From: Grant, David
Sent: 21 July 2023 09:07
To: _planningadvice
Subject: FW: Wests Nurseries H16-0574-23
Attachments: We sent you safe versions of your files; 660 - 2023_07_19 Surface Water Lagoon Details.pdf

SURFACE WATER DISPOSAL AT WESTS NURSERIES, MALLARD ROAD,
LOW FULNEY, SPALDING, PE12 6ND.

DETAILS OF SURFACE WATER LAGOON

Plan of Proposed Lagoon

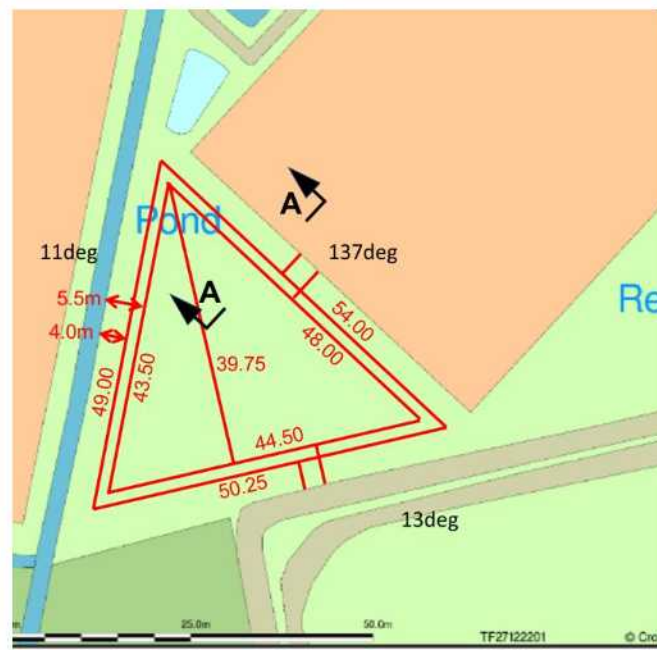
I hope you are well. A description of the proposed lagoon dimensions is provided on supporting information, however, no profile drawing of the lagoon has been submitted, solely drawings from above. I have discussed this matter with the Planning Manager and he is in agreement that a profile drawing should be provided, as well as details of how the lagoon will be made safe, such as boundary fencing and/or an escape ladder.

As the surface water lagoon is not a lined storage lagoon where water is stored (a deep water lined storage lagoon already exists on the site and does have a boundary fence around) the applicant does not feel the need for any boundary fencing but would provide escape steps

The required dimensions of this lagoon have been designed in a separate document. The lagoon will be formed by excavating the triangular area south west of the existing glasshouse 1.0 metre deep with side slopes with a slope of 1.5 to 1.0 (approximately 34 degrees to the horizontal). The angle of the side slopes will be similar to the batter of the dyke on the western side of the lagoon.

The lagoon will not be lined. The side slopes and base will be grassed which will be managed along with all of the grassed areas on the site.

The lagoon has been designed only to receive excess water from the existing lined reservoir on the north western side in heavy rainfall situations. At the present time it may only be filled with water for a period of a few days every 3 to five years, and therefore for 99% of the time the lagoon will be empty.
